Work Order ID 99348

Item Name: Crosstube Aft

DRAWING NO. D212-664-241	TITLE CROSSTUBE ASSY (205/212 HI AFT)	REV. D	DART AEROSPACE LTD ENGINEERING ORDER		D.E.O. NO. D212-664-241-D-1	SHEET NO. SHEET 1 OF 2	SCALE NTS
DRAWN	CHECKED		MFG. APPR.		APPROVED	DE APPR.	
DATE 11.04.07	DATE 11.04.11		DATE 11.04.12		DATE 11/04/12	DATE 11.04.12

DRAWING NO. D212-664-241	TITLE CROSSTUBE ASSY (205/212 HI AFT)	REV. D	<b>DART AEROSPACE LTD ENGINEERING ORDER</b>	D.E.O. NO. D212-664-241-D-1	SHEET NO. SHEET 2 OF 2	SCALE NTS
DRAWN	CHECKED <i>CP</i>	MFG. APPR. <i>E</i>	APPROVED <i>MD</i>	DE APPR. <i>MD</i>		
DATE 11.04.07	DATE 11.04.11	DATE 11.04.12	DATE 11/04/12	DATE 11.04.12

**FIGURE 1: SUPPORT INSTALLATION**

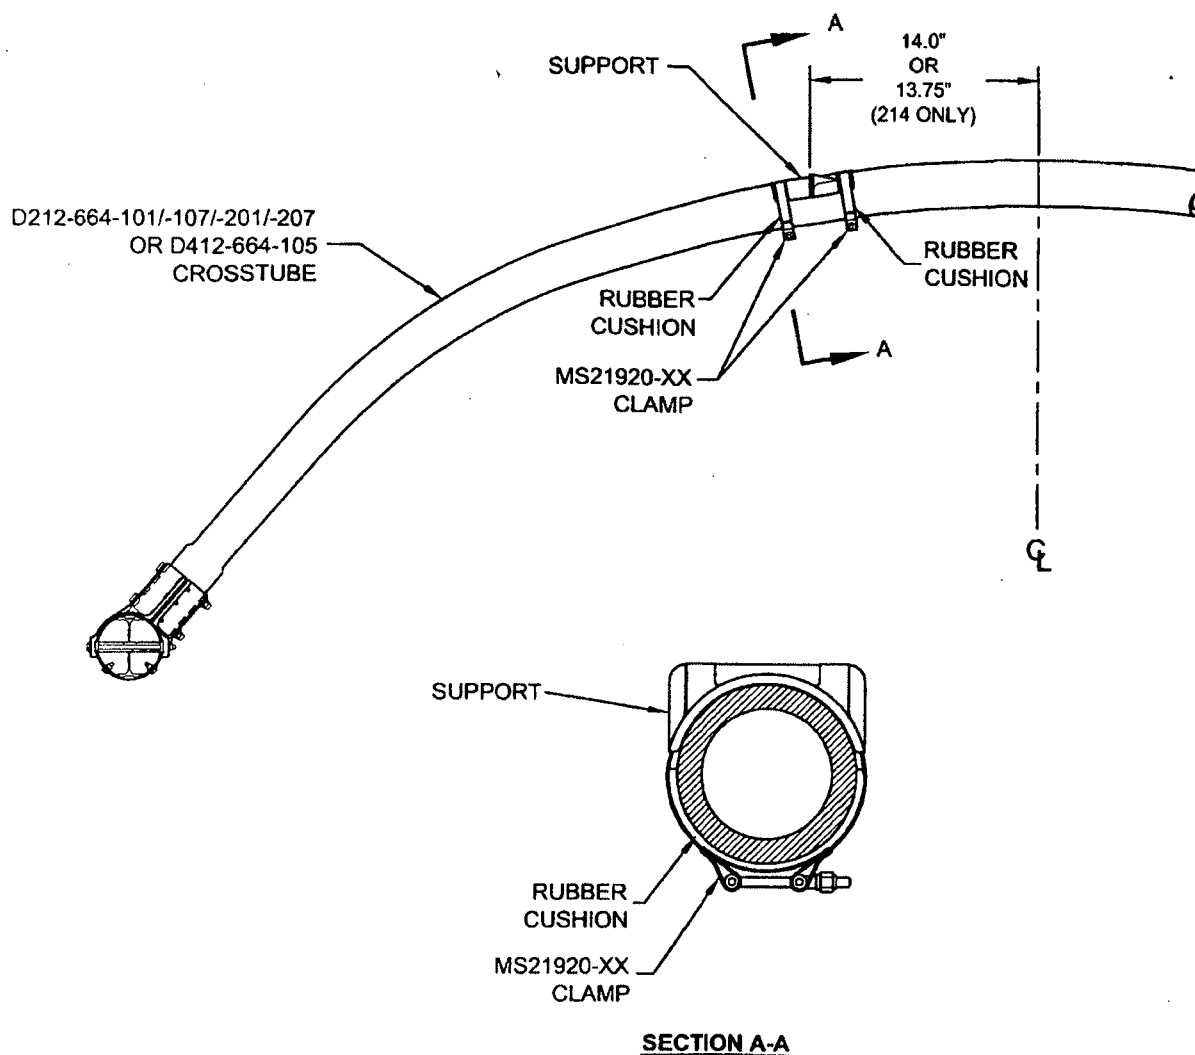
For the crosstubes listed above, section 32.4 of ICA-D212-664 is amended as follows. Use Figure 1 of this service instruction and Figures 32-2 to 32-9 of ICA-D212-664 for further reference. For crosstubes of an earlier change number, it is recommended that if the supports are removed, the supports should be reinstalled using the procedure listed below.

- 32.4.1 Locate the area on the crosstube for installation of support (see Figure 1 of this service instruction). For D212-664-101/-107/-201/-207 and D412-664-105 crosstubes, the outward face of the support tabs should be 14.0" (355mm) from the crosstube center for 204/205/210/412/UH-1 aircraft. For installation on 214B/B-1 aircraft, the outward face of the support tabs should be 13.75" (349mm). Ensure paint finish of crosstube is intact; touch up as required per Chapter 5 (5.3.9) of ICA-D212-664.

- 32.4.2 If present, remove any paint/primer on bottom of supports. Abrade mating surfaces of support and crosstube with 400-grit sandpaper. Saturate a clean cloth with MEK or 4105S Wash'n'Wipe Degreaser or equivalent and wipe until there is no residue.

- 32.4.5 Apply a 0.04" to 0.07" thick layer of Proseal 890 Class B or AMS-S-8802 Class B sealant underneath applicable support and install support as shown in Figure 1 of this service instruction.

- 32.4.6 Install the clamps opposite to crosstube support as shown in section A-A of Figure 1. Install rubber cushions underneath each clamp around the bottom circumference of the crosstube up to the crosstube centerline. Torque clamps 80-100 in-lb (9.0-11.3 Nm). It is acceptable to use smaller or larger sized MS21920-XX clamps than those listed in ICA-D212-664, ensure that after torquing the clamps per this instruction, the nuts are in safety but not bottomed out

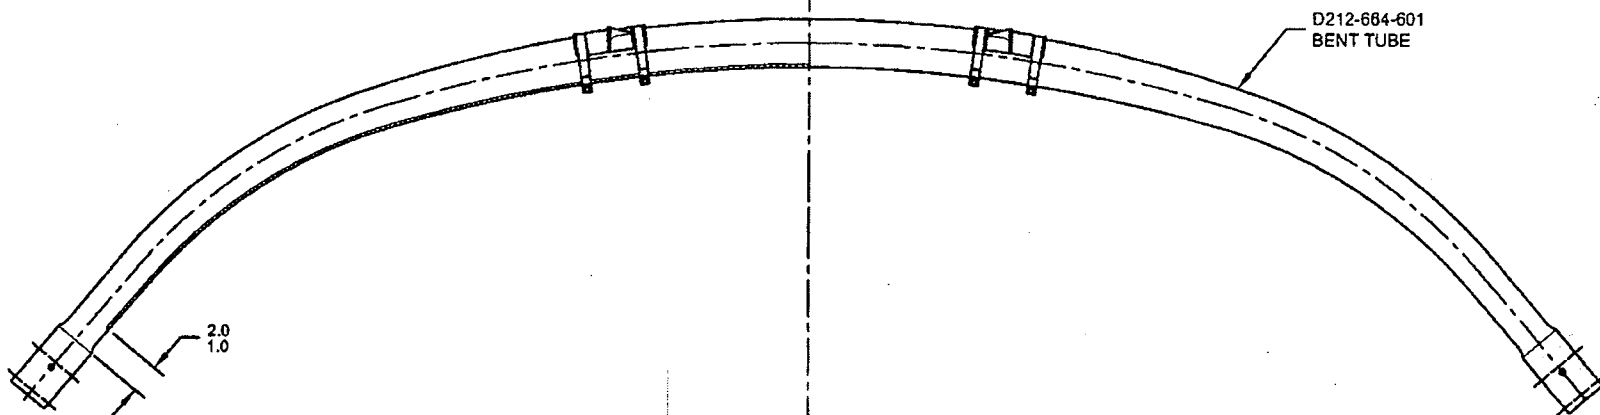
ADD AN INSPECTION WINDOW TO UNDERSIDE OF CROSSTUBE.

NOTES 2 OF SHEET 1 IS AMENDED AS FOLLOWS:

- 2) FINISH: CHEMICAL CONVERSION COAT PER DART QSI 005 4.1  
PRIME INSIDE AND OUTSIDE PER DART QSI 005 4.2  
MASK UNDERSIDE OF CROSSTUBE AS SHOWN (HATCHED AREA) AND  
PAINT OUTSIDE PER DART QSI 005 4.2  
REMOVE MASKING AND APPLY CLEAR COAT

MASK AREA PRIOR TO PAINTING,  
REMOVE MASKING AFTER PAINT  
AND APPLY CLEAR COAT

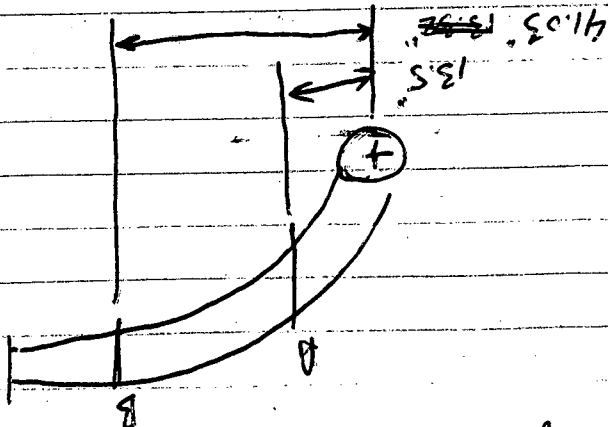
REPLACE MAGNOBOND WITH PROSEAL.

NOTE 12 & 15, SHEET 1 IS AMENDED AS FOLLOWS:

- 12) TO INSTALL D2940-1 SUPPORT: ABRASE MATING SURFACE OF SUPPORT AND CROSSTUBE WITH 180-GRIT SANDPAPER AND REMOVE RESIDUE WITH MEK (OR EQUIVALENT). APPLY A 0.04" TO 0.07" THICK LAYER OF PROSEAL 890 CLASS B-2 (OR AMS-S-8802 CLASS B-2) SEALANT TO MATING SURFACE OF SUPPORT.
- 15) TORQUE CLAMPS 80 TO 100 IN-LB. ENSURE AT LEAST 1.5 THREADS SHOWING IN SAFETY AND THAT NUT HAS NOT BOTTOMED-OUT AFTER TORQUING. **PRIOR TO PACKAGING, RE-CHECK TORQUE ON CLAMPS AFTER PROSEAL 890 SEALANT HAS CURED FOR 72 HOURS.**

- 12) INSTALL D2940-1 SUPPORT USING 0.03" TO 0.06" THICK LAYER OF MAGNOBOND 6398 TO THE SURFACE OF D2940-1 THAT WILL BE IN CONTACT WITH THE CROSSTUBE PER QSI 015. LET CURE FOR 12 HOURS AFTER INSTALLATION AND PRIOR TO PACKAGING.
- 15) TORQUE CLAMPS 80 TO 100 IN-LB. ENSURE AT LEAST 1.5 THREADS SHOWING IN SAFETY AND THAT NUT HAS NOT BOTTOMED-OUT AFTER TORQUING.
